BIG SANDY *Energy Project*

Supplement Analysis

*U.S. Department of Energy
Western Area Power Administration
DOE/EIS-0315-SA-01*

May 2002

Figure 1

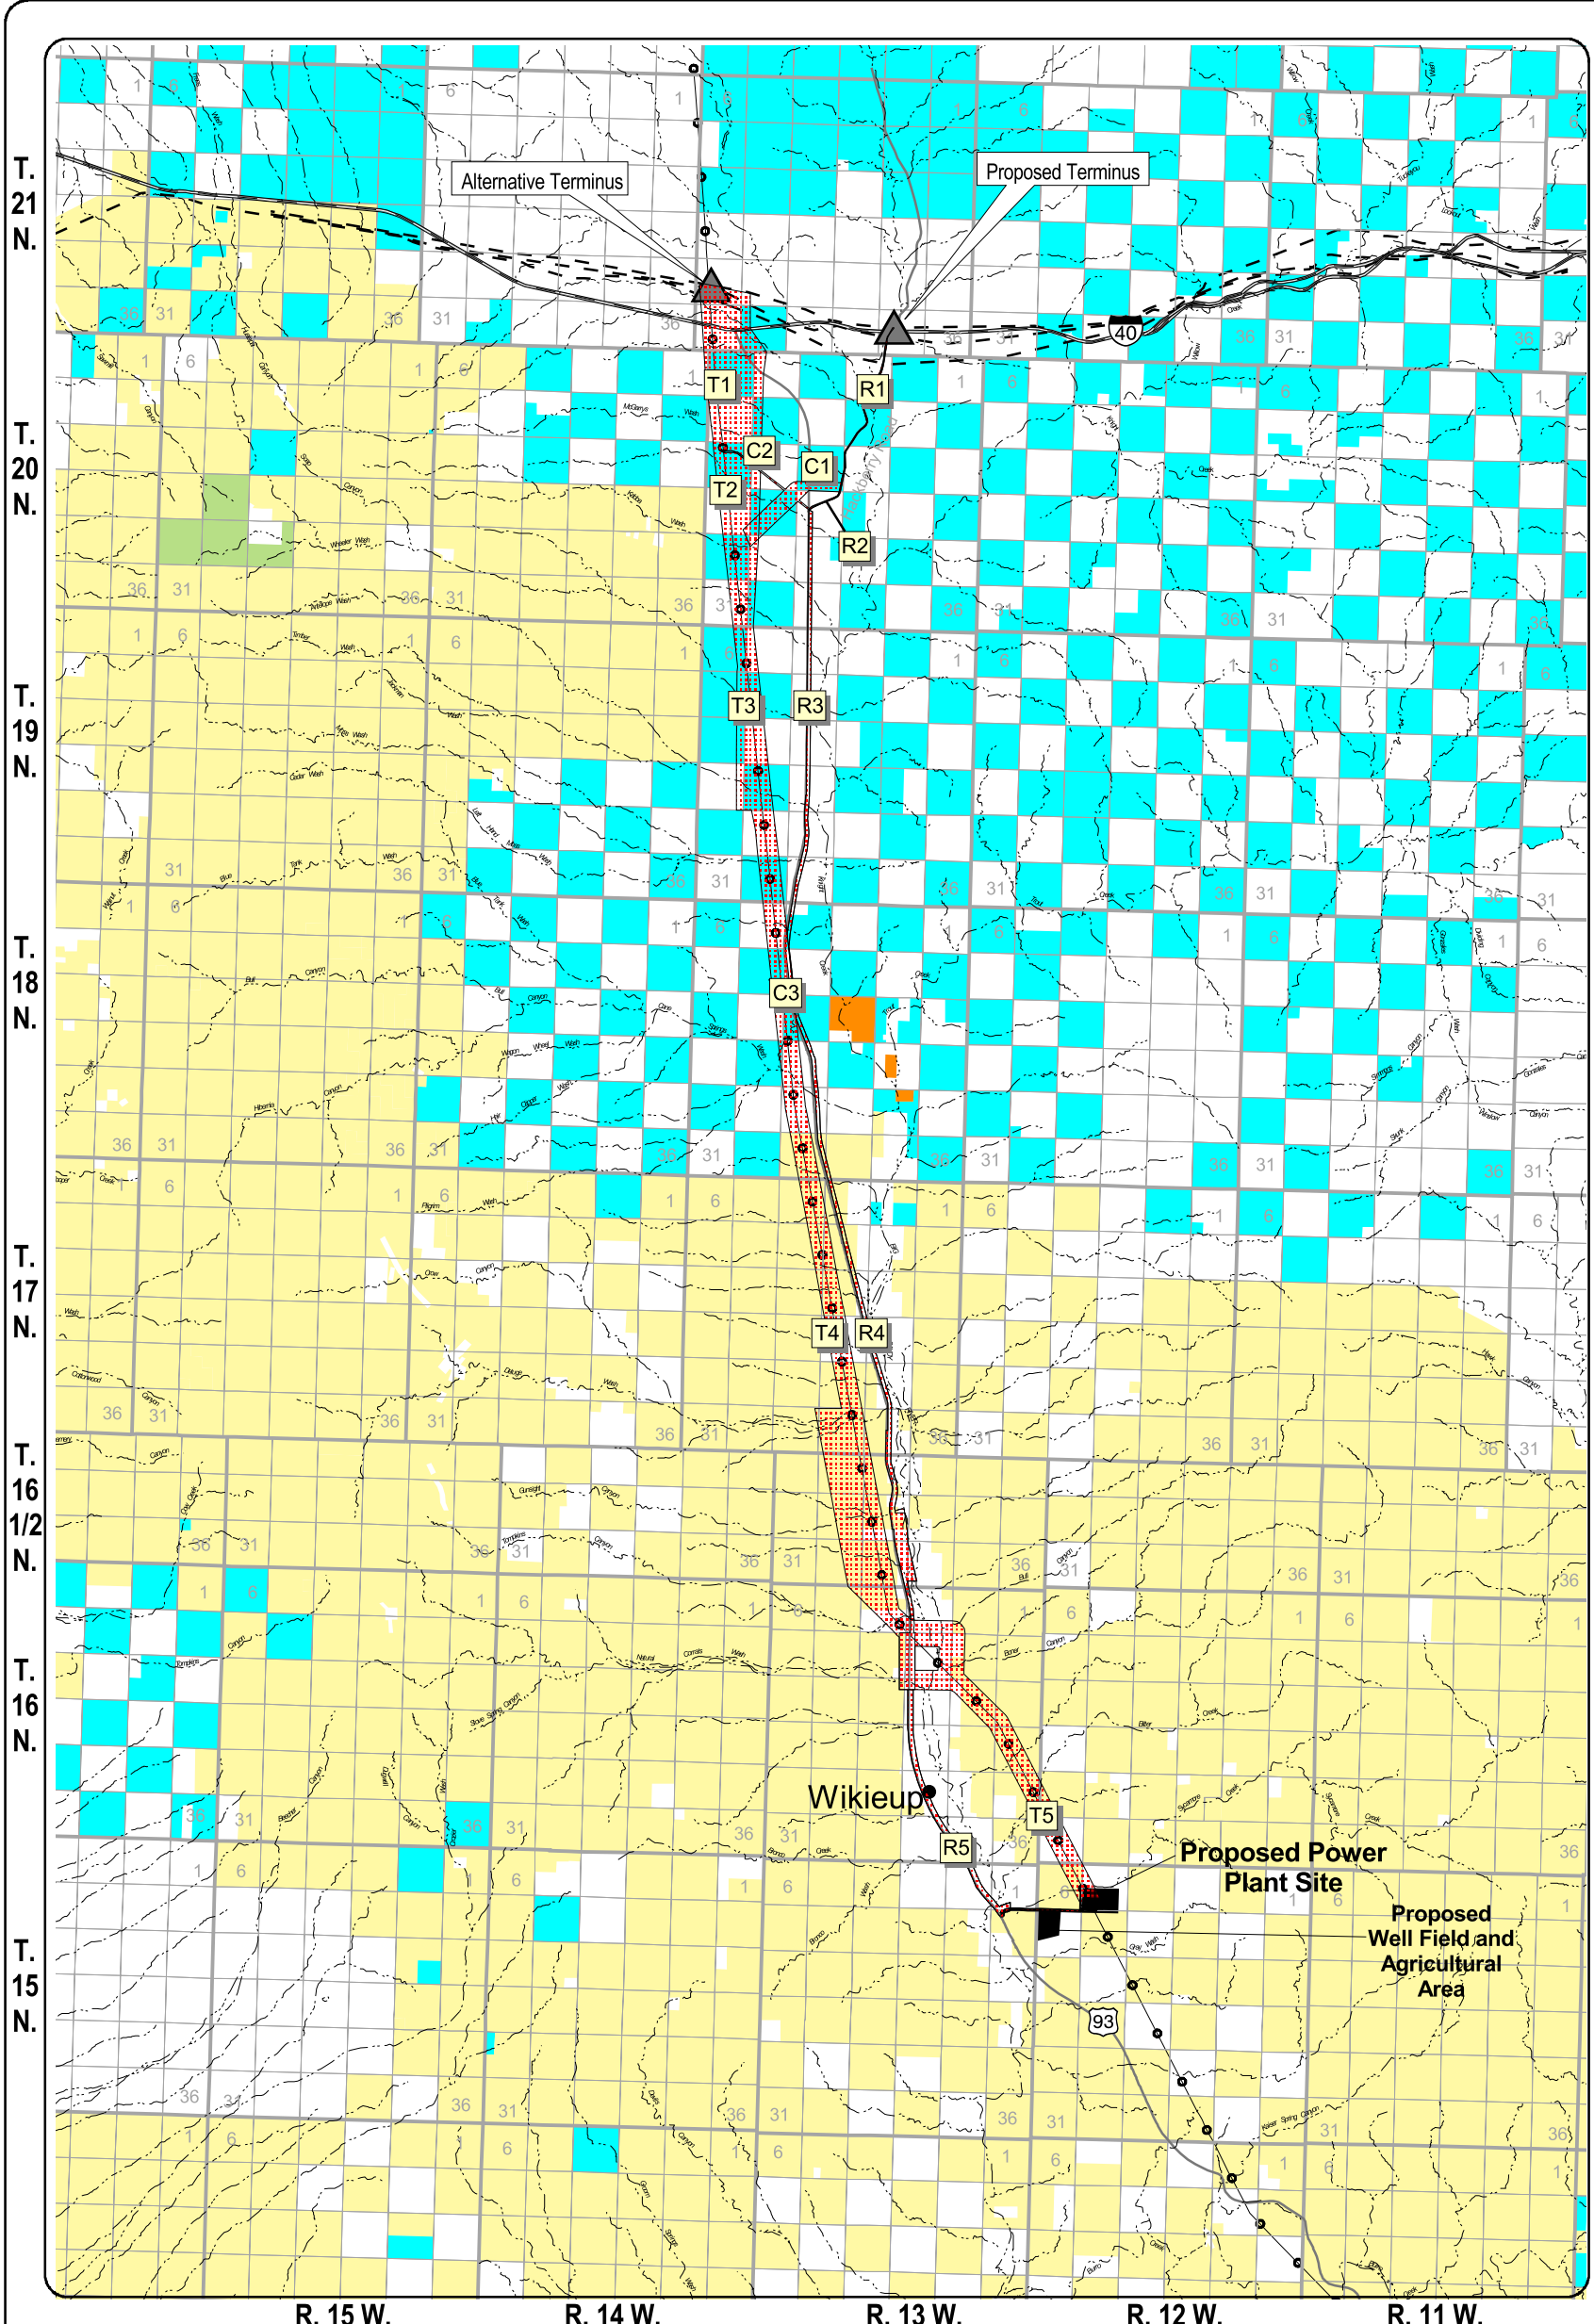
Caithness has revised the Drainage Plan for the plant site, presented in the Draft EIS as Figure 2-15. Caithness has also revised the Stormwater Pollution Prevention Plan included in the Draft EIS as Appendix A and discussed in Section 2.2.8.4 of the Draft EIS. Stormwater would no longer flow into the evaporation ponds, but instead would flow into separate sediment ponds (Steltenpohl 2001). These unlined ponds would function as infiltration basins; they would be sized to meet the design criteria presented in the Draft EIS for the evaporation ponds (which were formerly designed to hold both stormwater and cooling tower blowdown) (Doenges 2001). Four sediment ponds located along the southern and western boundaries of the plant site would permanently disturb three acres (Koblitz 2001d). Figure 1, the revised Drainage Plan Map (Koblitz 2001d) shows the locations of the sediment ponds.

Caithness has revised both the design and location of the evaporation ponds (originally described in Section 2.2.1.6, Waste Management and presented in Figure 2-4a of the Draft EIS). Instead of two evaporation ponds covering 18 acres, Caithness now proposes three evaporation ponds covering approximately nine acres (Steltenpohl 2001) and disturbing 13 acres (Koblitz 2001d). Caithness has also revised the pond design to include a double high-density polyethylene (HDPE) liner instead of the single HDPE liner and one clay liner described in the Draft EIS (Koblitz 2001b). In addition, stormwater would no longer be directed into the evaporation ponds. The location of the three proposed evaporation ponds is depicted in Figure 1, Drainage Plan Map.

Caithness has proposed a new emergency access road to enhance plant security and safety. It will enter the proposed plant site from the north (Steltenpohl 2001, Koblitz 2001b). The emergency access road would disturb six acres (Koblitz 2001d). This road would not be used daily, and would be bladed but not paved (Doenges 2001). See Figure 1, Drainage Plan Map for the location of the road.

Caithness has revised the fence line along the northern side of the proposed plant site to enclose the new emergency access road (Koblitz 2001e). Before this revision, the fence line closely paralleled the off-site storm water ditch shown in Figure 2-15 of the Draft EIS. The location of the revised fence line and storm water ditch are shown on Figure 1, Drainage Plan Map.

Wetland #2 is located immediately south of the proposed access road at the proposed plant site. The Draft EIS states that about 0.64 acre of this wetland would be on Project property. Caithness has revised the grading (cut and fill) for the proposed plant site, including the access road described in the Draft EIS, which increases the area of direct impact to Wetland #2, as defined in the Draft EIS (Section 3.12.1.1). The area of proposed fill in Wetland #2 is 0.08 acres as depicted in Figure 1, Drainage Plan Map.

Proposed Access Road
 Big Sandy Energy Project SA

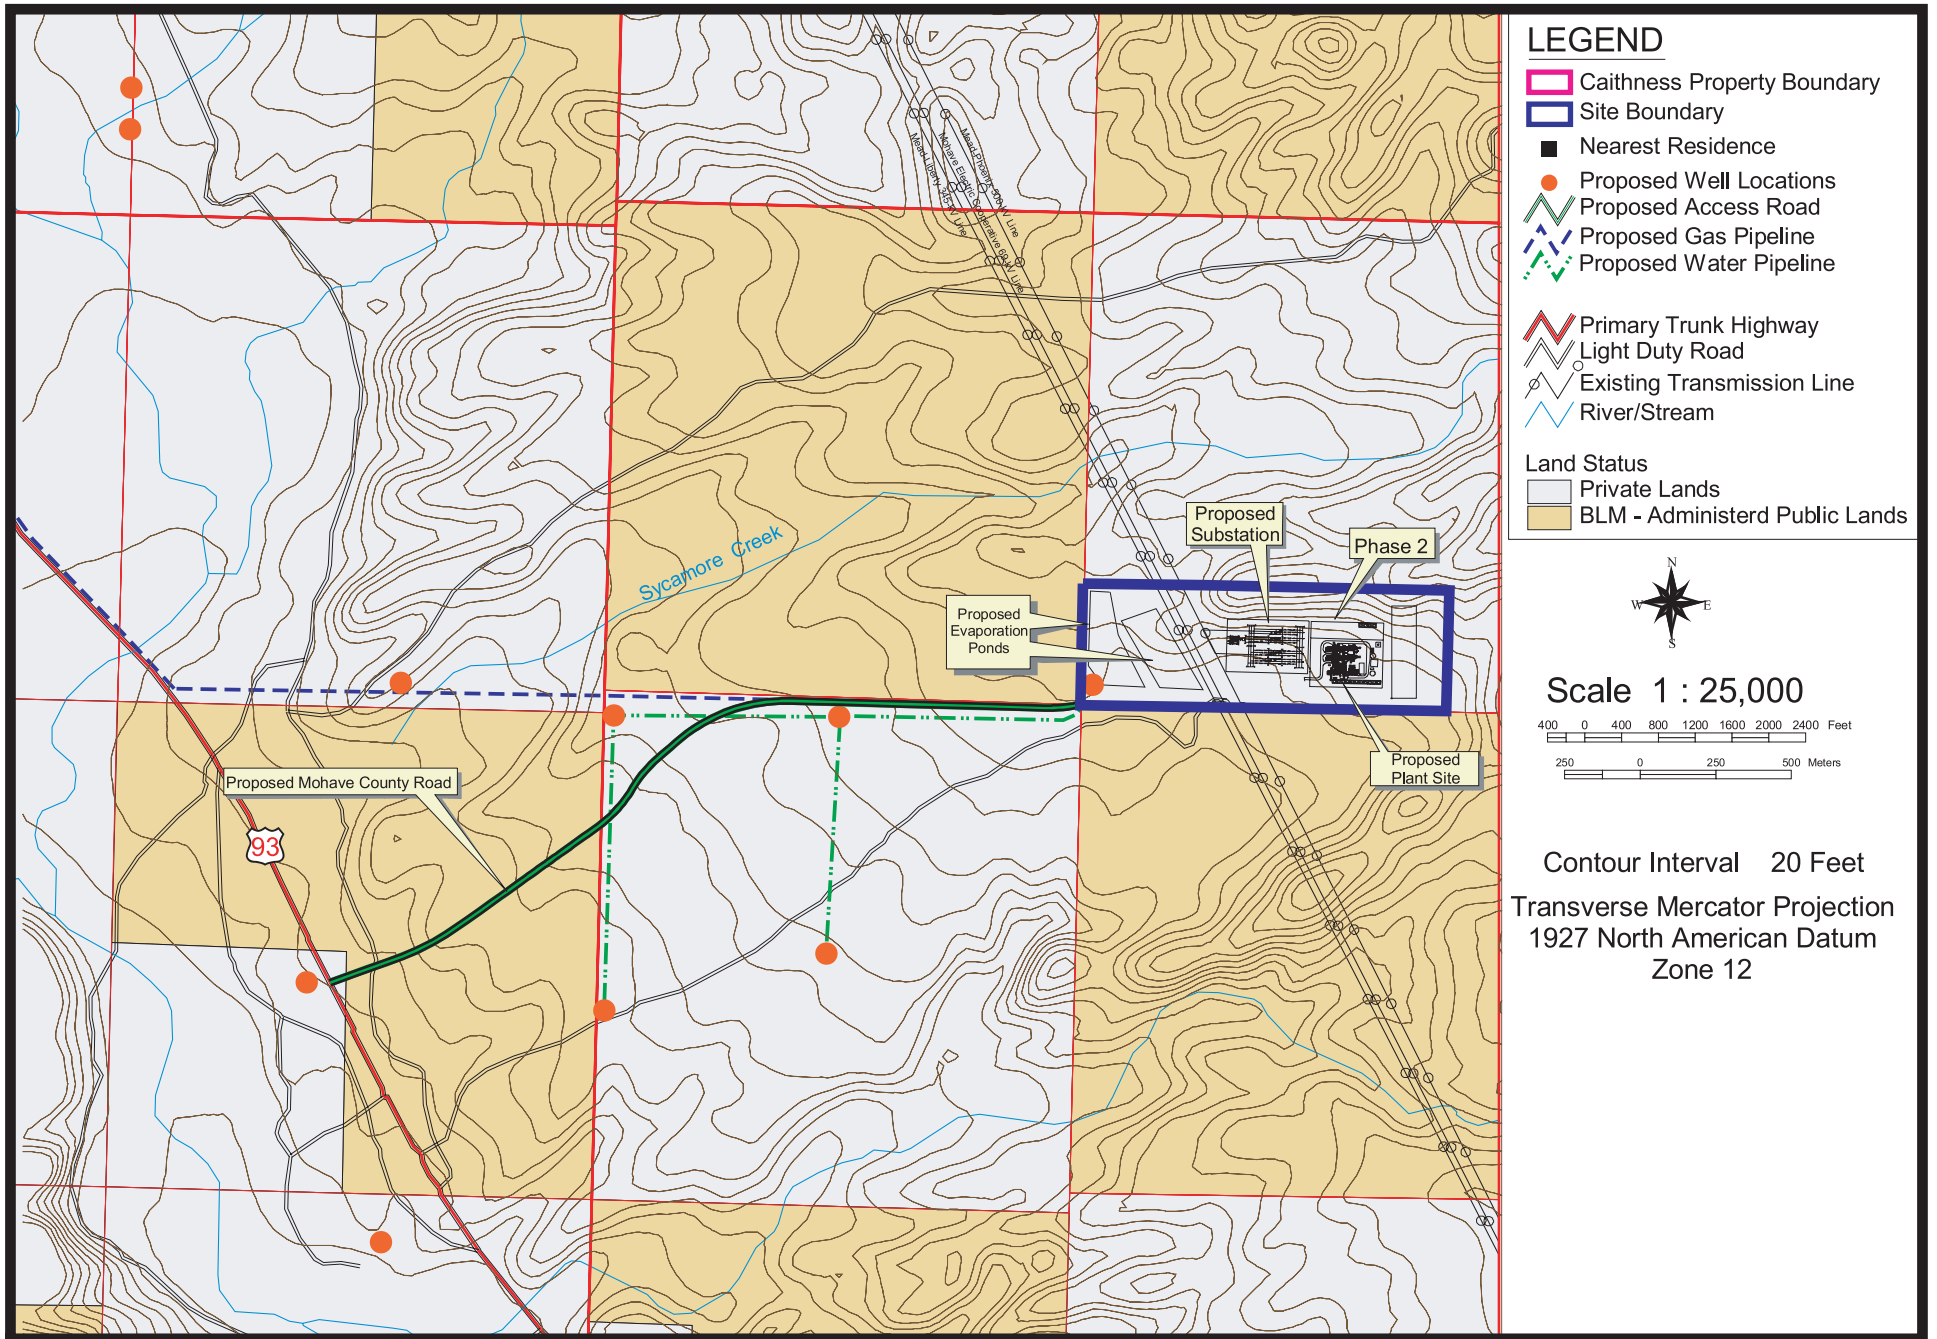
Caithness has proposed an optional alignment for the access road to the plant site (Doenges 2001). Figure 3, Proposed Access Road shows the location. The access road would be built to the same specifications as described in Section 2.2.7.4 of the Draft EIS; if selected it would also be a Mohave County Road. The optional alignment would enter and leave the plant site at the same location, but would intersect U.S. 93 south of the proposed access road alignment described in the Draft EIS. Caithness would determine which access road would be built (assuming that either option is approved by the agencies).
